Access Compliance Report

Public Rights-of-Way

Intersection ID: 10041481	Main Street: WESTPARK_DR	Cross Street: N/A	Location: NW
ADA ID: F72277537875	Ramp Type: PerpDiag	Initial Pass/Fail: Fail	Overall Compliance: No
			Severity Score: 50

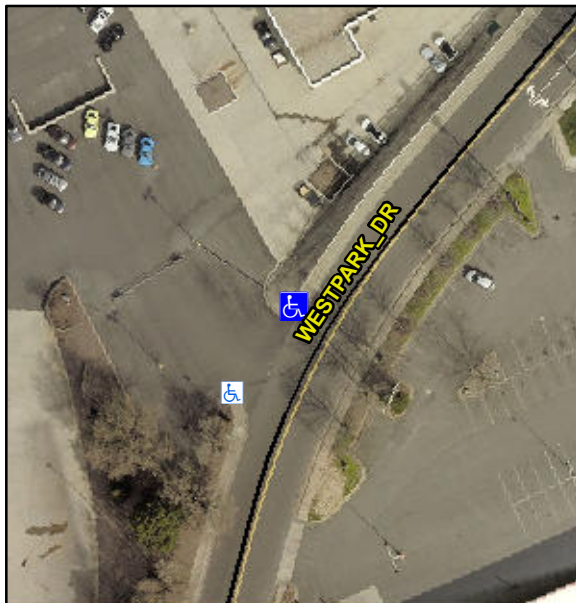
Not Found, R304.2.2, R304.5.3

Compliance	Description	Data	Compliance	Description	Data
N/A	Ramp Length (in)	49.0	No	Ramp Slope (%)	25.6
Yes	Ramp Width (in)	48.0	No	Ramp XSlope (%)	11.4
N/A	Flare Type LT	N/A	N/A	Flare Type RT	N/A
N/A	Flare Slope LT (%)	N/A	N/A	Flare Slope RT (%)	N/A
N/A	Flare Traversable LT?	N/A	N/A	Flare Traversable RT?	N/A
N/A	Landing Length (in)	N/A	N/A	DWS Provided?	N/A
N/A	Landing Width (in)	N/A	N/A	DWS Contrast?	N/A
N/A	Landing Slope (%)	N/A	N/A	DWS Length (in)	N/A
N/A	Landing X Slope (%)	N/A	N/A	DWS Full Width?	N/A
N/A	Landing Curb? (Y/N)	N/A	N/A	DWS Offset (in)	N/A
N/A	Shared Landing?	N/A			
N/A	Gutter Ponding?	N/A	N/A	Gutter Slope (%)	N/A
N/A	Gutter Lip Ht (in)	N/A	N/A	Gutter X Slope (%)	N/A
N/A	Painted X Walk1?	No	N/A	Painted X Walk2?	No
	X Walk 1 Direction	To SW		X Walk 2 Direction	To SE
N/A	X Walk 1 Width (in)	N/A	N/A	X Walk 2 Width (in)	N/A
	X Walk 1 Slope (%)	2.1		X Walk 2 Slope (%)	9.5
	X Walk 1 X Slope (%)	15.8		X Walk 2 X Slope (%)	1.2

Remove & Replace Curb Ramp With Two New Directional Ramps or Equivalent.
